**October 2025**

# Helios Renewable Energy Project

## The Applicant's Response to the Secretary of State's Request for Information

Planning Inspectorate Reference: EN010140

Figure A.1: Combined Constraints Plan

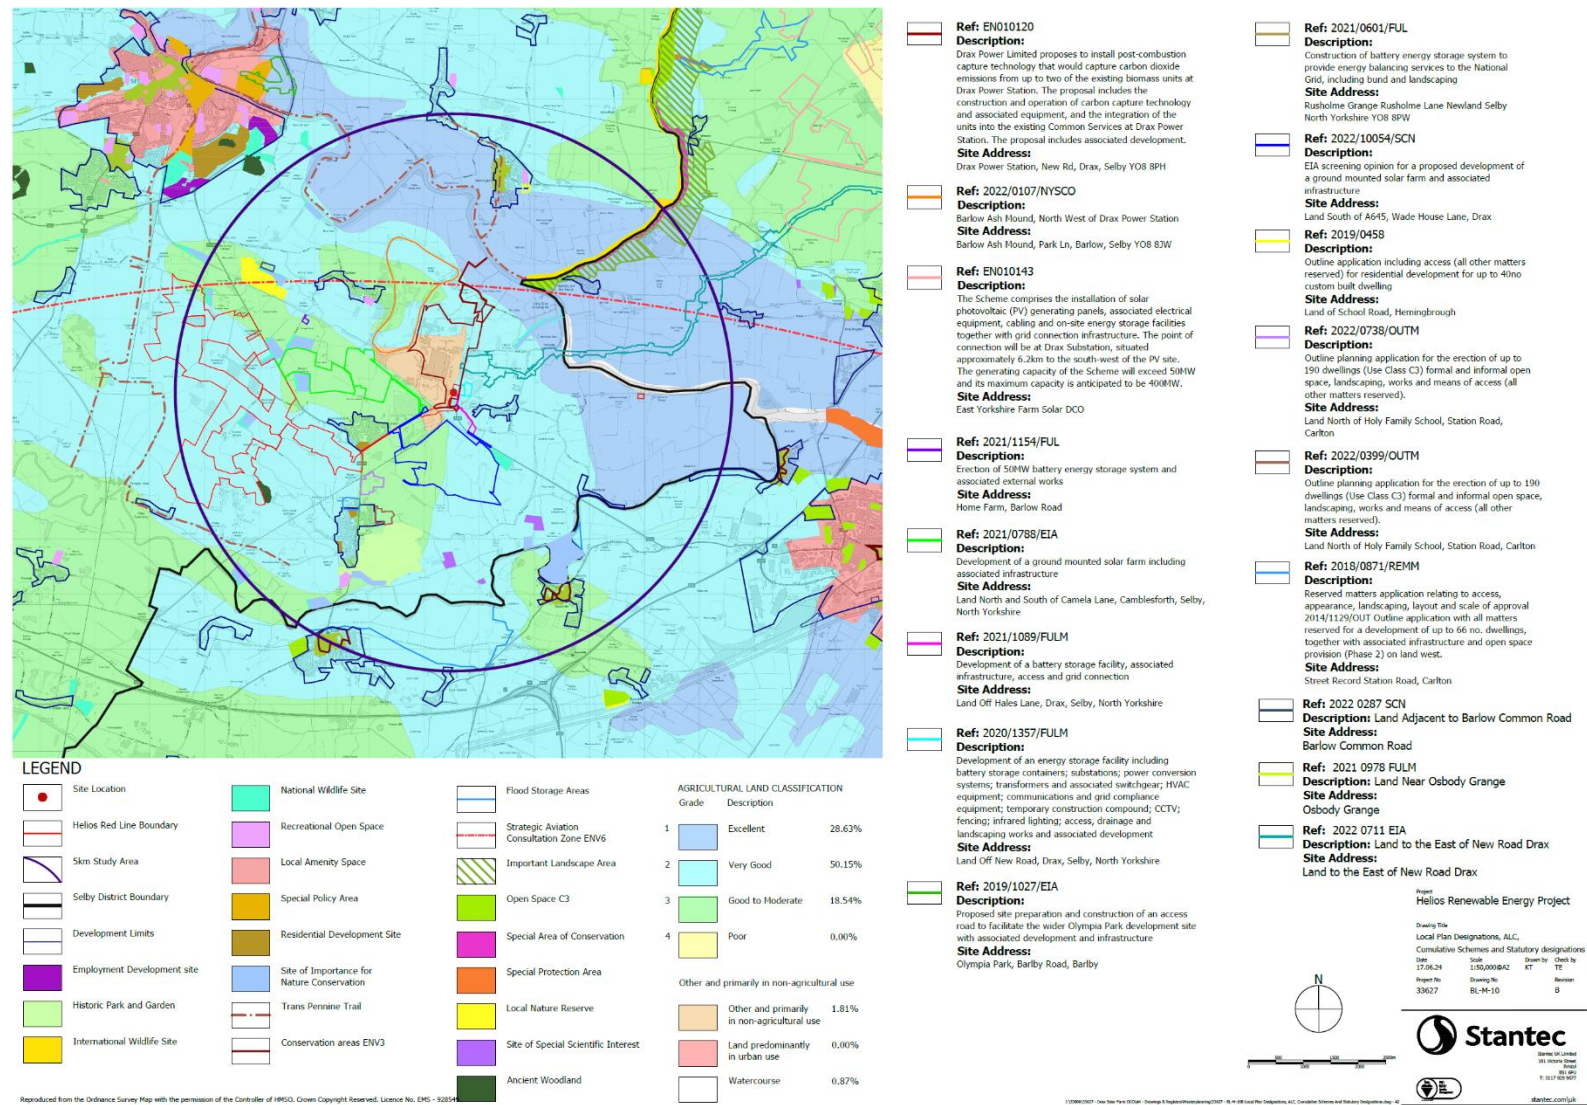
- 3.2.22. In accordance with the requirements of NPS EN-1 and EN-3 to use lower grade agricultural land in preference to higher quality, the Applicant considered the band of provisional Grade 3 land for siting the Proposed Development. However, as can be seen on Figure A.1 that land was unavailable because:

- 3.2.20. As shown on Figure A.1 of Appendix A, all land of a size capable of accommodating the Proposed Development within the 5km search area is of some degree of BMV agricultural land, with the exception of the land occupied by Drax Power Station. The siting of the Proposed Development on BMV agricultural land within the 5km search radius is therefore unavoidable.

**Figure B.1: GLF areas from runway 07 relative to the Proposed Development**

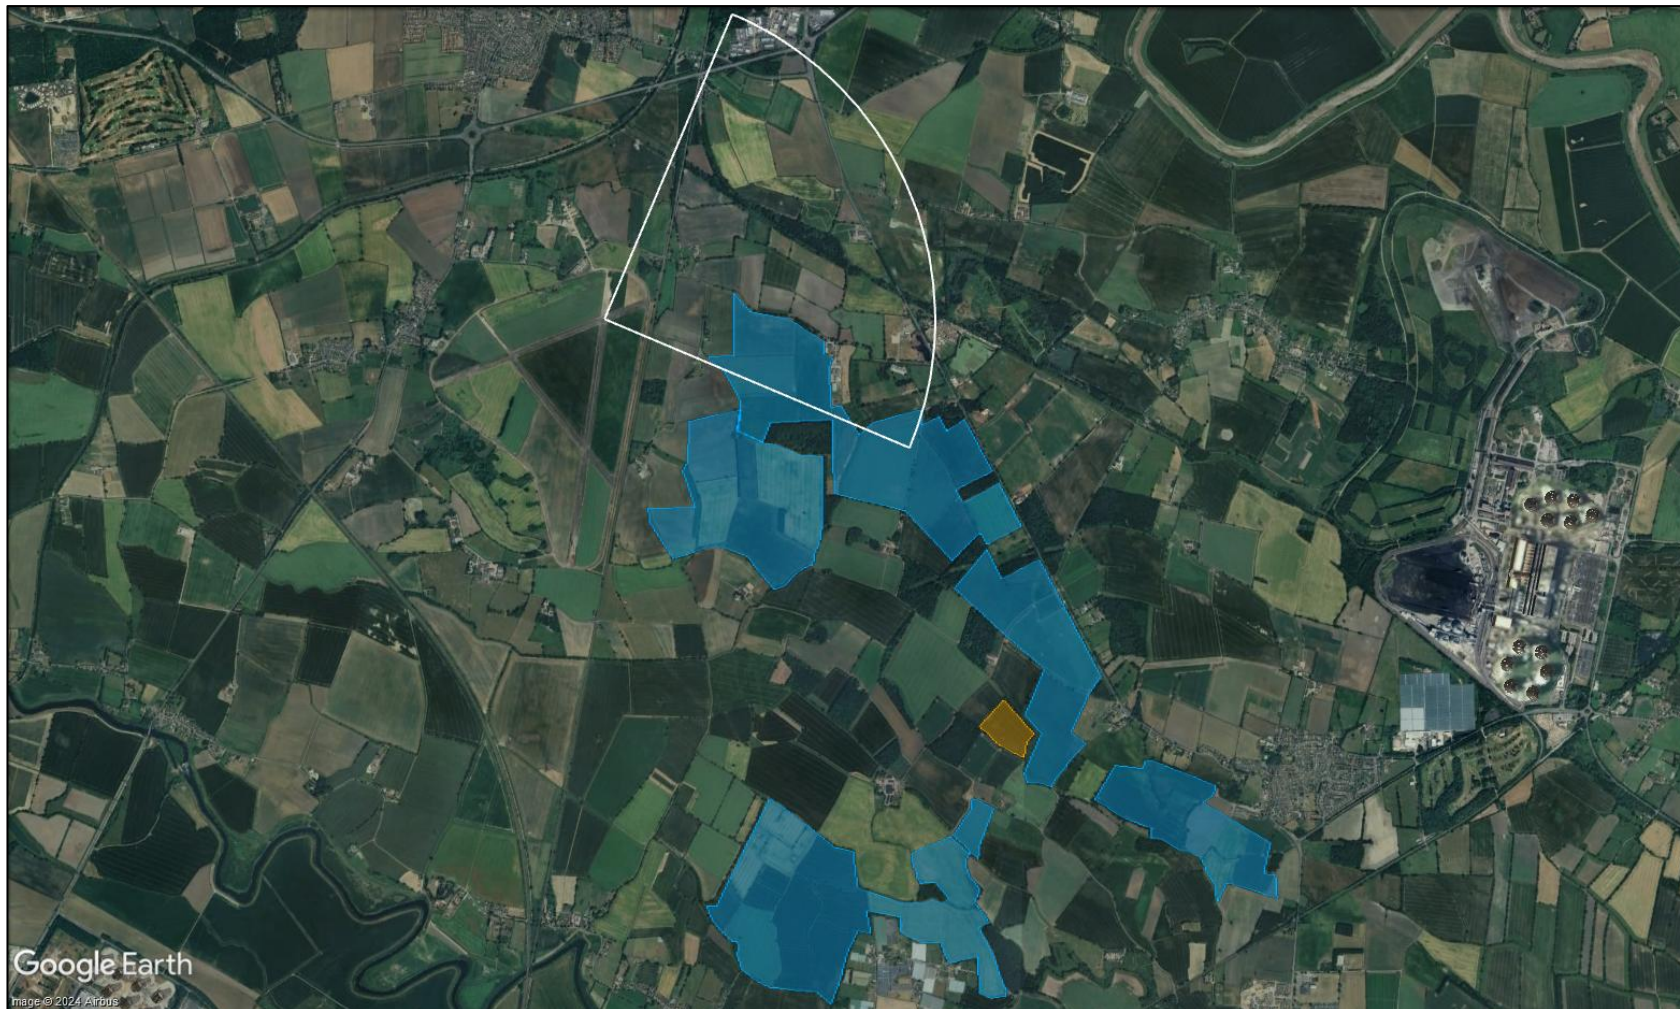
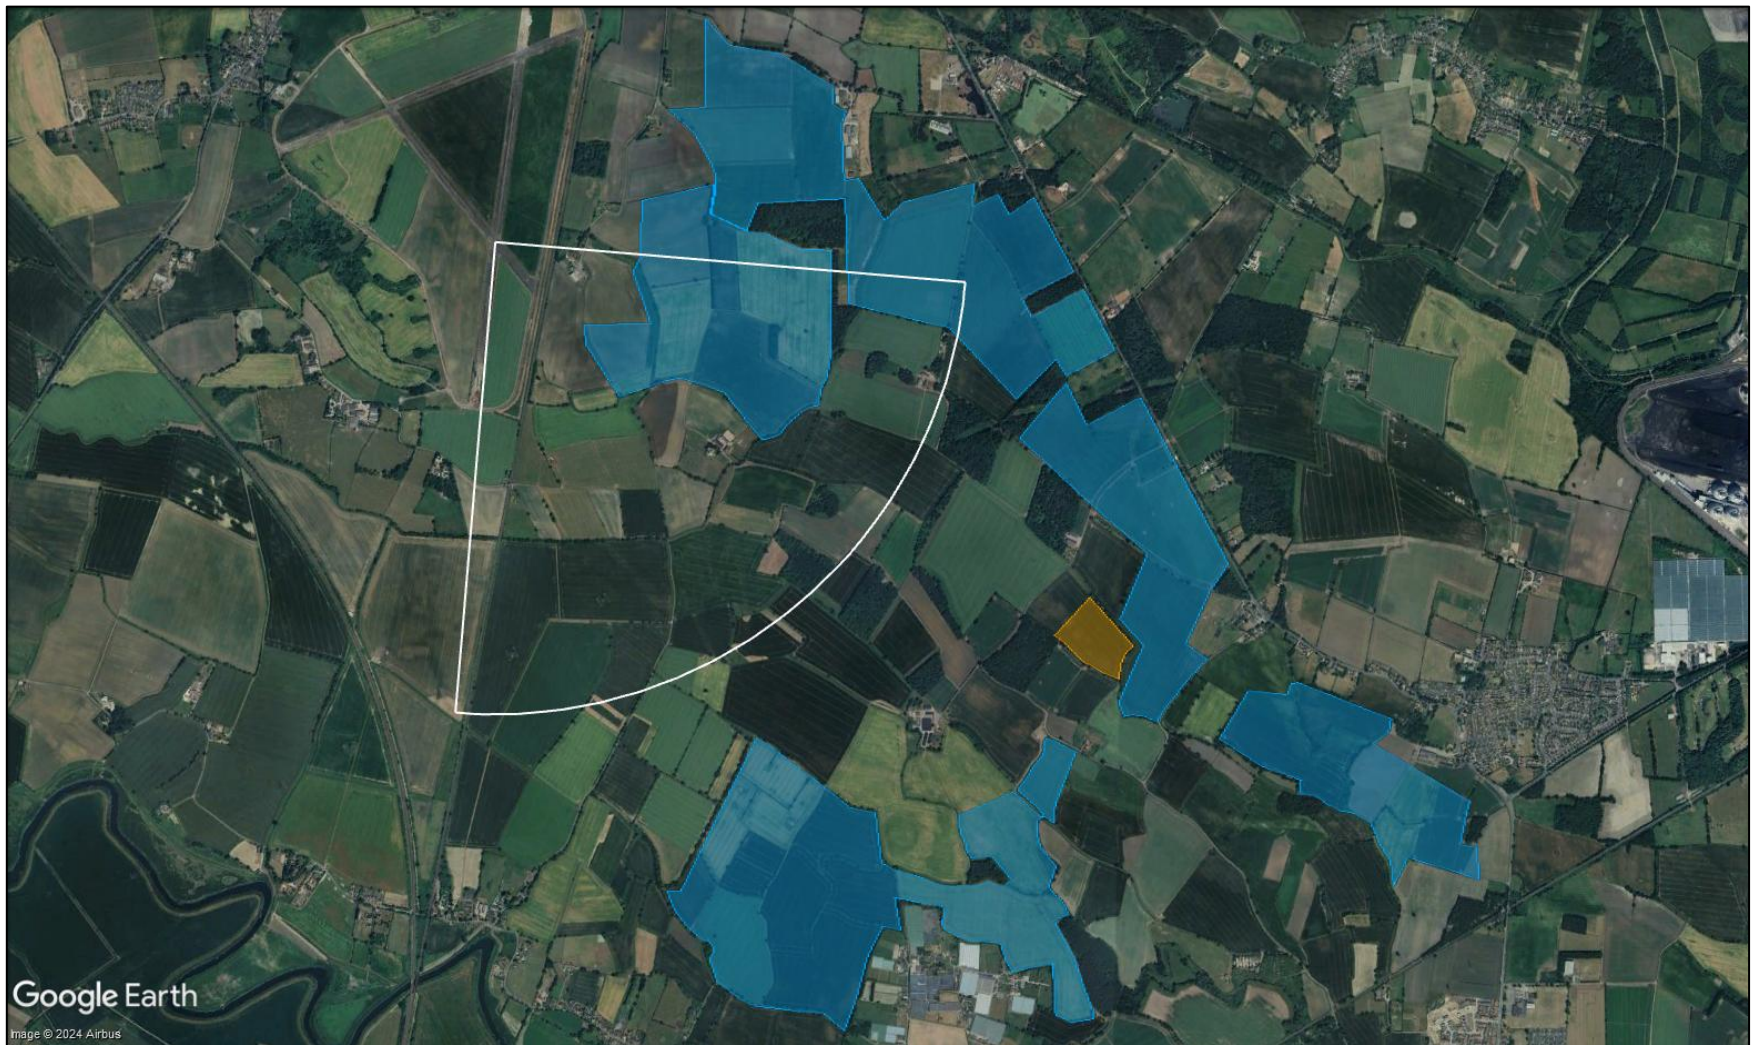
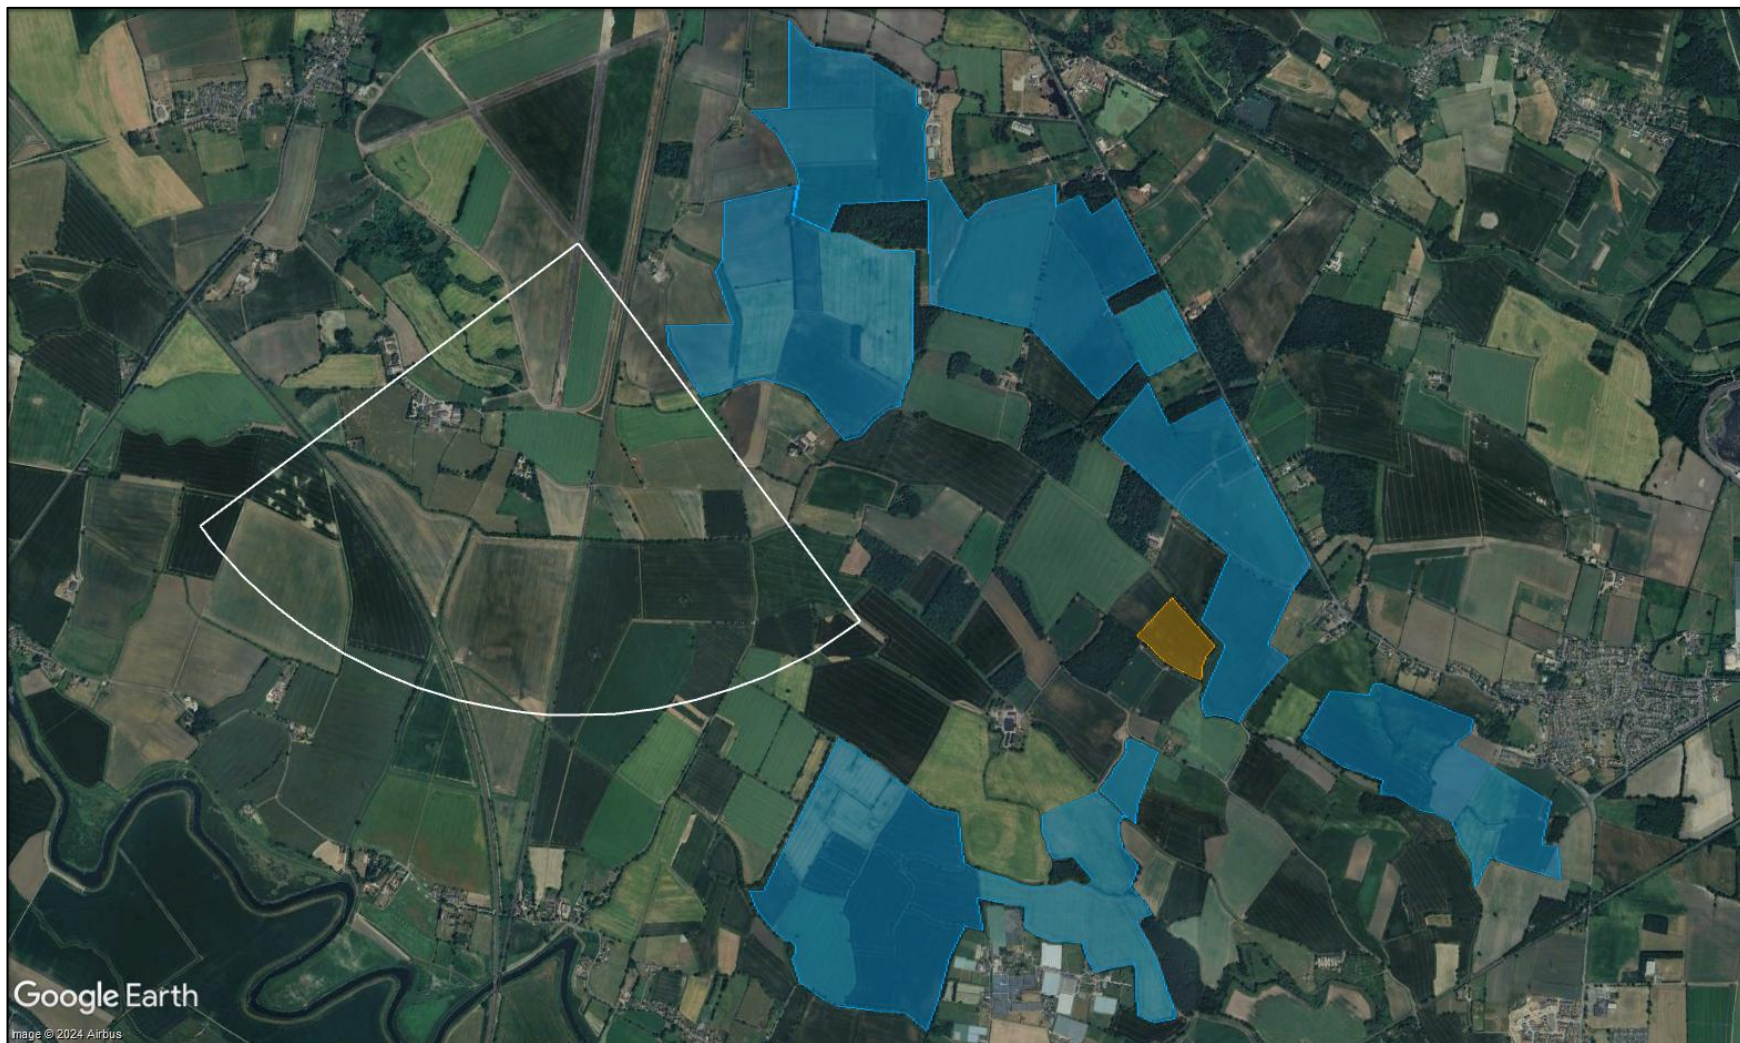
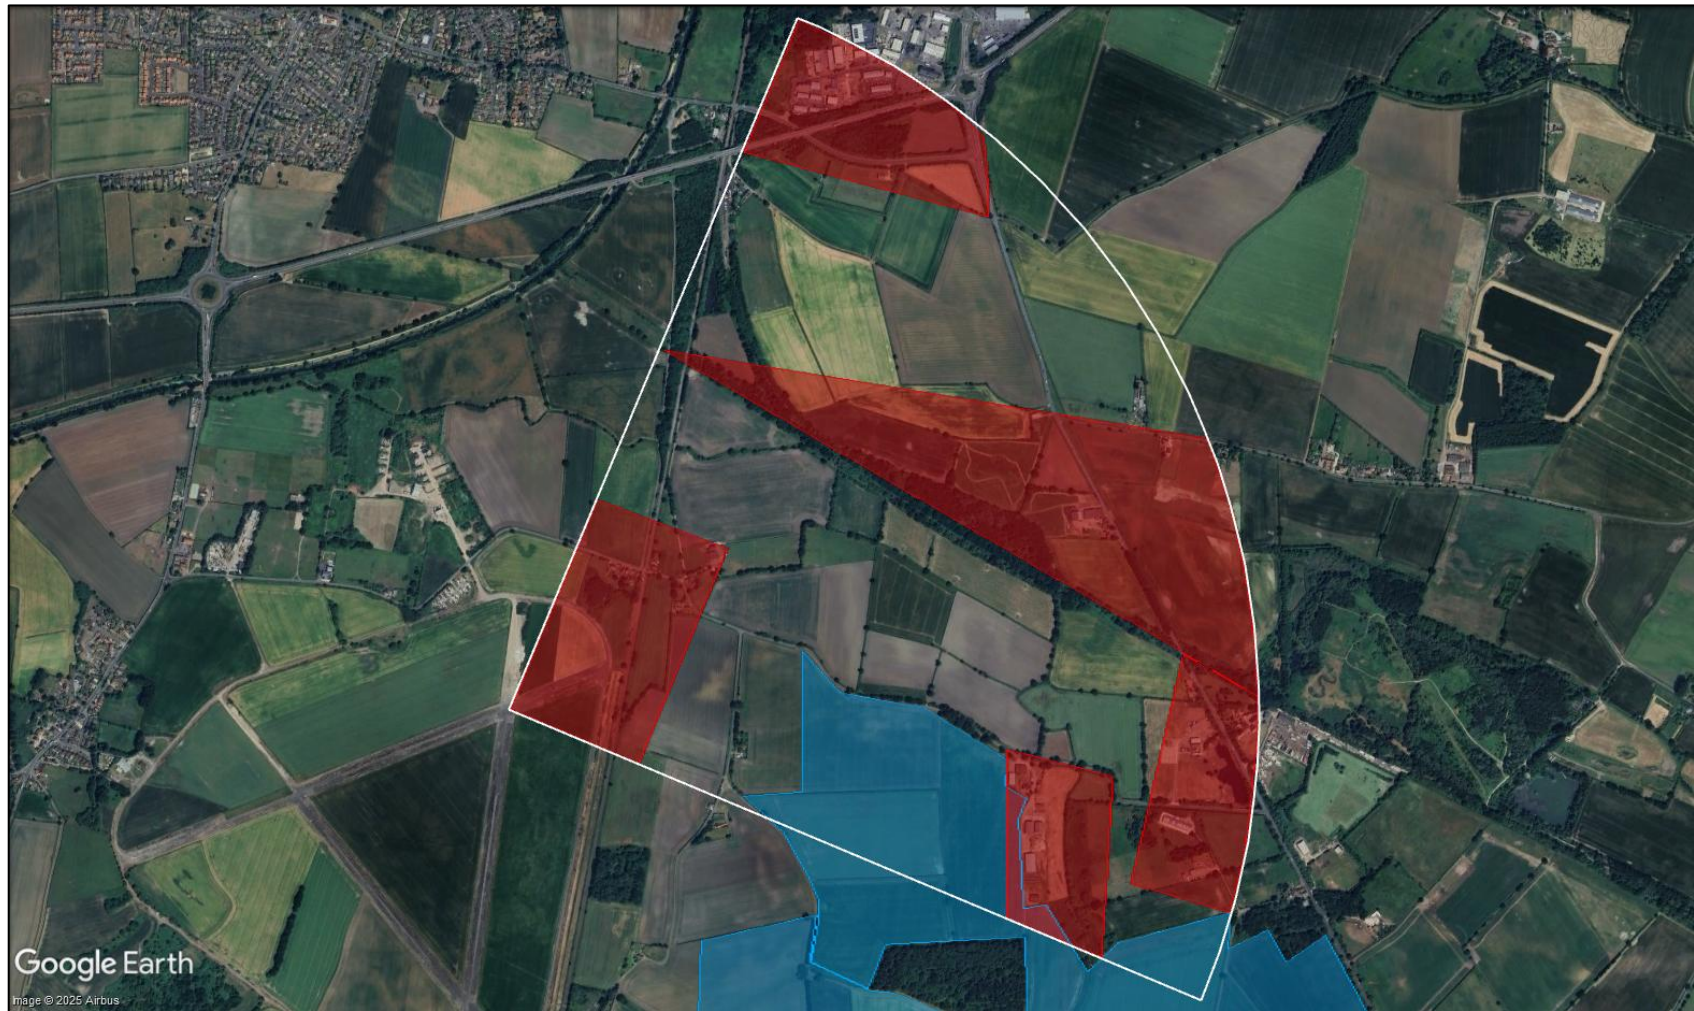
- 4.2.6. Paragraph 7(b) of the RfI states:

- 4.2.12. Figures from the High-level Investigative Report showing the land available for GLF in relation to the Proposed Development and land not deemed suitable by Burn Gliding Club are re-provided for ease of reference within Appendix B of this submission (Figures 3 to 7 of the High-level Investigative Report **[REP7-017]**). Figures B.1 to B.3 of Appendix B show the areas of land relative to the Proposed Development within 2km from the launch points (runway intersections), considering 45 degrees either side of the runway centreline. The Proposed Development is shown in Figure B.3 not to reduce the area defined for GLF from runway 19, and as such, runway 19 has not been included in Table 4.1 above. Figures B.4 and B.5 show for runways 07 and 15 areas that are not suitable for an emergency landing (in areas of red) relative to the panel areas (blue) and the BESS (orange) for the Proposed

**Figure 2.1: Environment Agency Flood Map for Planning (06/10/2025)**

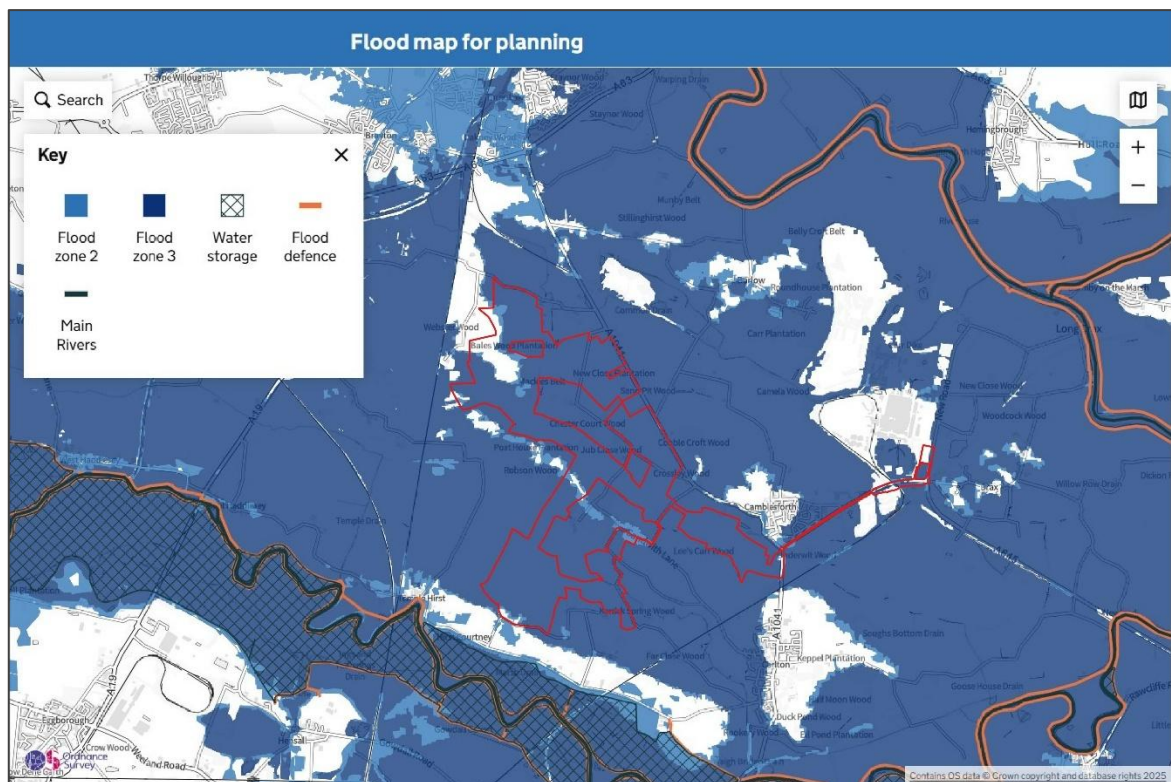
- 1.4. With respect to Flood Risk, point 22 states:
- "The Secretary of State notes that the Environment Agency has published new data following an update to the National Flood Risk Assessment. The Flood Map for Planning and flood zones were also updated on 25 March 2025. The Applicant should explain whether the updates have any implications for the conclusions of the Environmental Statement, including APP-029 Environmental Statement Chapter 9: Water Environment and REP7-008 Flood Risk Assessment. The Applicant should provide revised documents, as necessary."**

2.3. The 'Flood Map for Planning' was also updated and presents different scenarios from the new national modelling and is relevant for the application of planning policy.
